Latest Garments Ltd. (10077)

519, Chator, Chotobari, Post-DUET, Gazipur

24.MAY.2014

1st Priority 2 Concern

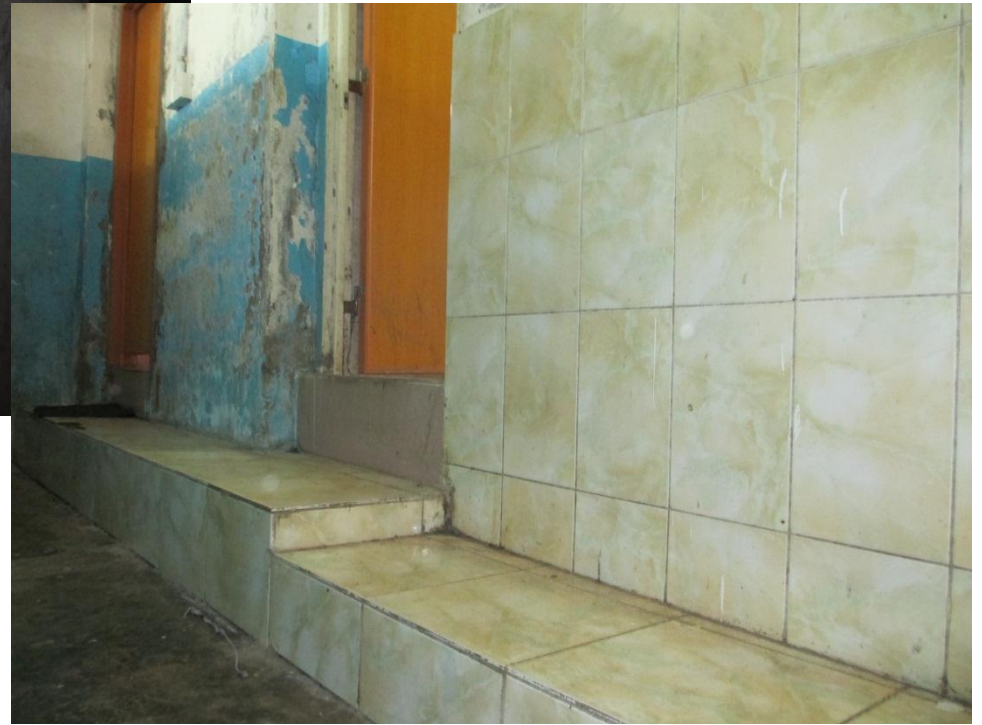
Slight over-stress in columns, established through column load run-down.

Left, the ground floor column from which the plaster was removed to establish that brick aggregate had been used. Below is the significant floor build-up under the toilet areas, which contributes significantly to the stress in the columns.

Following the scanning of a typical internal column to establish the reinforcement, and the column load run-down spreadsheet, a 'yellow' rating for the column stress was established.

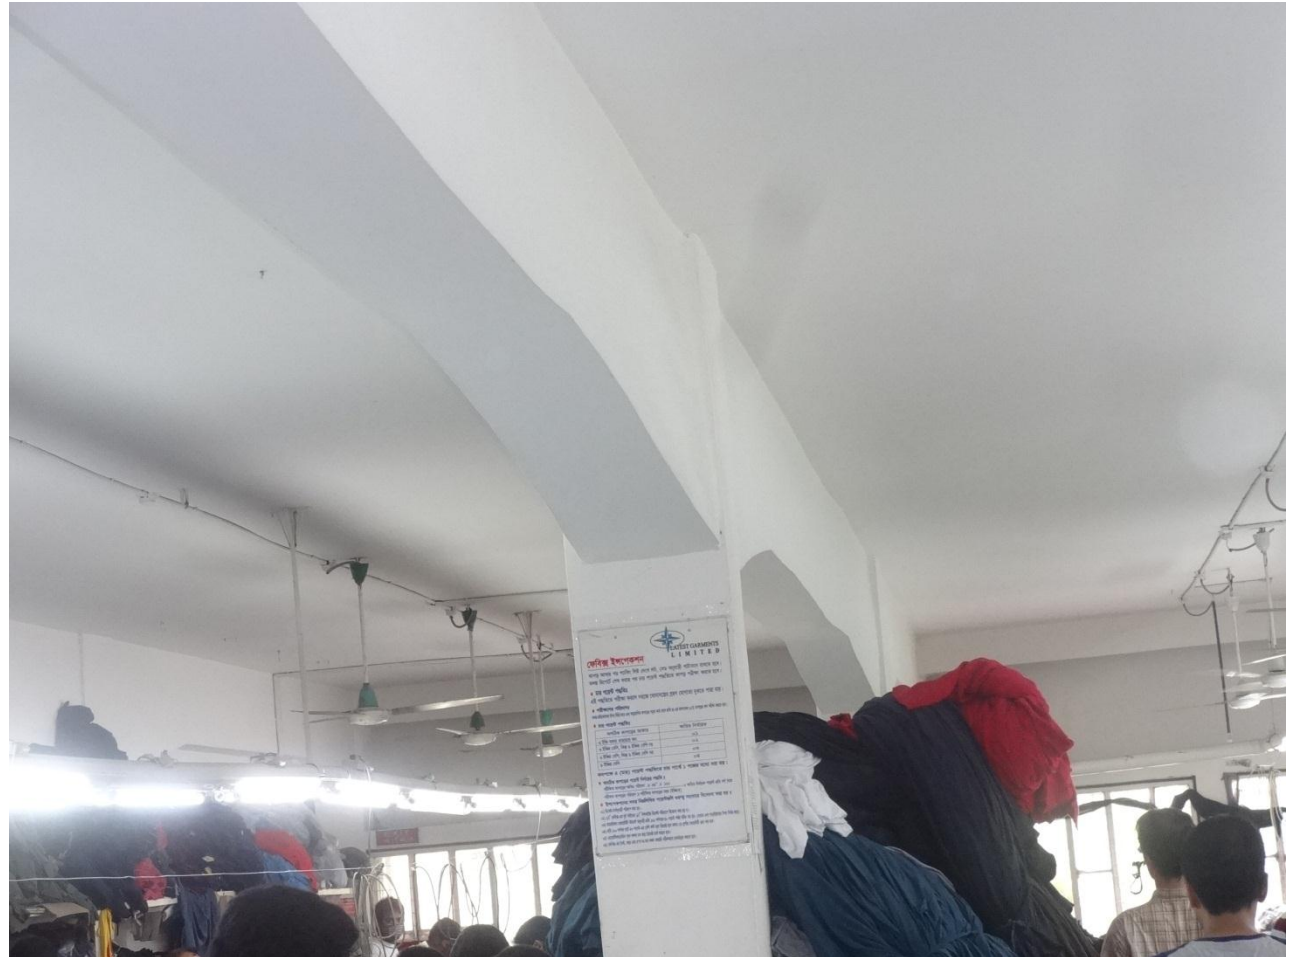
To the right is an internal image from the factory, showing very deep down-stand beams in one direction, providing stability through moment frame action. In the other direction however, no sufficient lateral stability system could be established. This should be further investigated in the form of a Detailed Engineering Assessment.
